Access Compliance Report

Public Rights-of-Way

Intersection ID: 4732	Main Street: GEMWAY_DR	Cross Street: OLDBRIAR_LN	Location:	N
ADA ID: 716CDACB4C9B	Ramp Type: Perp	Initial Pass/Fail: Fail	Overall Compliance: No	Severity Score: 13.75

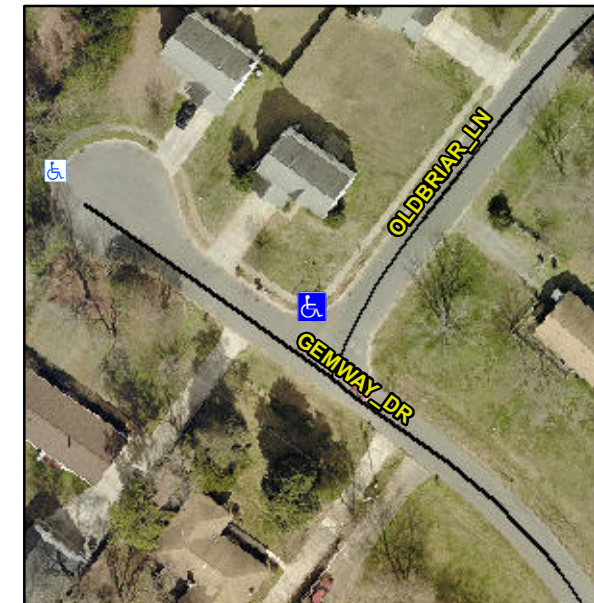
Not Found, R304.2.2, R304.5.3

Compliance	Description	Data	Compliance	Description	Data
N/A	Ramp Length (in)	48.0	No	Ramp Slope (%)	9.9
Yes	Ramp Width (in)	48.0	No	Ramp XSlope (%)	2.1
N/A	Flare Type LT	N/A	N/A	Flare Type RT	N/A
N/A	Flare Slope LT (%)	N/A	N/A	Flare Slope RT (%)	N/A
N/A	Flare Traversable LT?	N/A	N/A	Flare Traversable RT?	N/A
N/A	Landing Length (in)	N/A	N/A	DWS Provided?	N/A
N/A	Landing Width (in)	N/A	N/A	DWS Contrast?	N/A
N/A	Landing Slope (%)	N/A	N/A	DWS Length (in)	N/A
N/A	Landing X Slope (%)	N/A	N/A	DWS Full Width?	N/A
N/A	Landing Curb? (Y/N)	N/A	N/A	DWS Offset (in)	N/A
N/A	Shared Landing?	N/A			
N/A	Gutter Ponding?	N/A	N/A	Gutter Slope (%)	N/A
N/A	Gutter Lip Ht (in)	N/A	N/A	Gutter X Slope (%)	N/A
N/A	Painted X Walk1?	No	N/A	Painted X Walk2?	N/A
	X Walk 1 Direction	To SE		X Walk 2 Direction	N/A
N/A	X Walk 1 Width (in)	N/A	N/A	X Walk 2 Width (in)	N/A
	X Walk 1 Slope (%)	1.2		X Walk 2 Slope (%)	N/A
	X Walk 1 X Slope (%)	1.3		X Walk 2 X Slope (%)	N/A

Remove & Replace Entire Ramp.
